DOCUMENT 00 91 02 – ADDENDUM NO. 2

PROJECT: Ord Village Lift Station & Force Main Replacement Project

CIP NO.: OS-0147

ISSUED: January 15, 2021

CONCRETE ENCASUREMENT

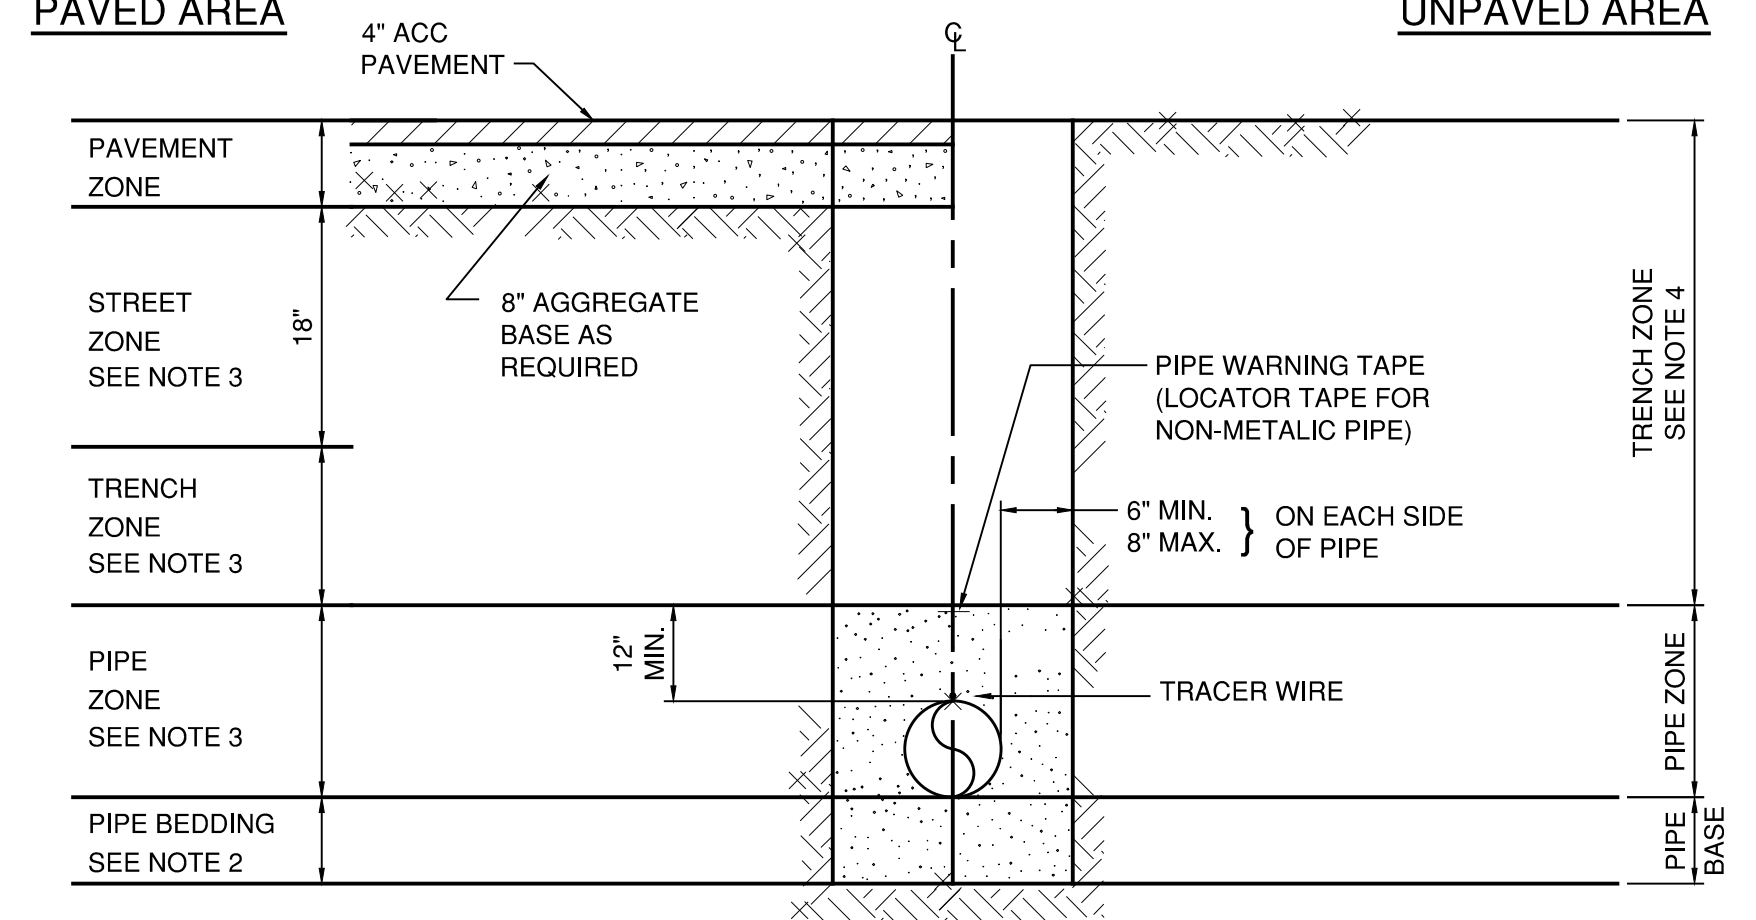
- A. Sheet 10, Plan & Profile (6 of 6) is reissued. A table of manhole depths is added.
- B. Sheet 15, Sewer Details (1 of 4), is reissued. Details for concrete foundation pads are added.
- C. Sheet 18, Sewer Details (4 of 4), is reissued. The label for Detail 1 is corrected.

Q5 Please provide a bid item and detail for the low point blow off on sheet 7 station 16+20.29.

Q21 Can you clarify the trench compaction requirements (Sheet 18, Detail 5)?

A5 The Blow-off Detail is mislabeled on Sheet 18. The corrected sheet is included in this Addendum. Include the cost of the Blow-Off in Bid Item 11, which is revised to include it.

A21 The detail shows both paved and unpaved areas. Compaction under and around the pipe is 95% Modified Proctor. Under pavement, the trench backfill is also at 95% Modified proctor. If not under pavement, the trench backfill is at 90% Modified Proctor.
